## Product Change Notification / GBNG-17ZWEX736

CCB 4959 Initial Notice: Qualification of MMT as a new assembly site for selected SMSC LAN91C11xx device family available in 128L TQFP (14x14x1mm) package.

**CCB 4959**  
**Pre and Post Change Summary**  
**PCN #: GBNG-17ZWEX736**

# LEAD FRAME COMPARISON

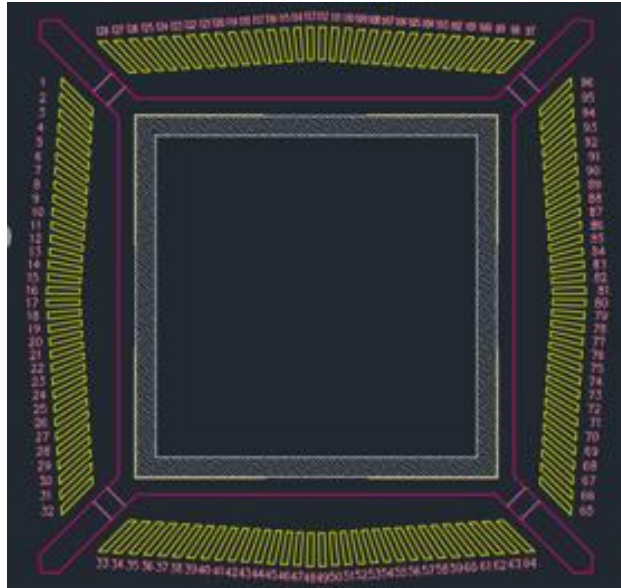
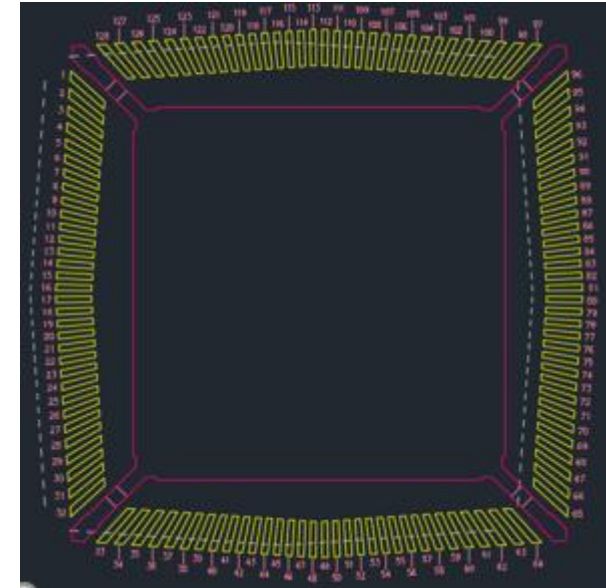
Lead frame paddle size	240 x 240 mils
Lead frame DAP surface prep	Double Ring

Lead frame paddle size	252 x 252 mils
Lead frame DAP surface prep	Bare Cu
